APPLICATION NO.	FILING DATE	FIRST NAMED INVENTOR	ATTORNEY DOCKET NO.	CONFIRMATION NO.
10/698,521	11/03/2003	Jacques Habatjou	233773US26	1399
22850	7590	01/17/2007		
OBLON, SPIVAK, MCCLELLAND, MAIER & NEUSTADT, P.C. 1940 DUKE STREET ALEXANDRIA, VA 22314			EXAMINER DOAN, ROBYN KIEU	
			ART UNIT	PAPER NUMBER
			3732	
SHORTENED STATUTORY PERIOD OF RESPONSE	MAIL DATE	DELIVERY MODE		
3 MONTHS	01/17/2007	PAPER

Office Action Summary

DETAILED ACTION

Attachment A

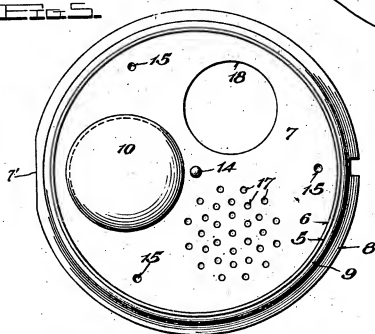
base part and containing the product. In regard to claim 7, the cup having a free edge (8) against which the sealing member can bear. In regard to claim 10, the lid is pivotable with respect to the base part (at 7a, fig. 4). In regard to claims 24-26, Callowhill et al discloses a base (1) having a first compartment (10) and a second compartment (see attachment A), a lid (2) coupled to the base and movable to a closed lid position, a cover (12) with a central portion (14) and a peripheral portion, the cover member being coupled to the lid via the central portion of the cover member so that said peripheral portion is pivotable about at least one axis passing through the central portion; wherein in a closed position, the peripheral portion of the cover member (12) bears against an edge of the first compartment (10) so as to seal the first compartment and the second compartment is covered by the lid (2). In regard to claims 27, 30, 31, the case having a cosmetic product in the first compartment (col. 2 line 60). In regard to claim 32, the central portion having a ball (14) joint in a receptacle.
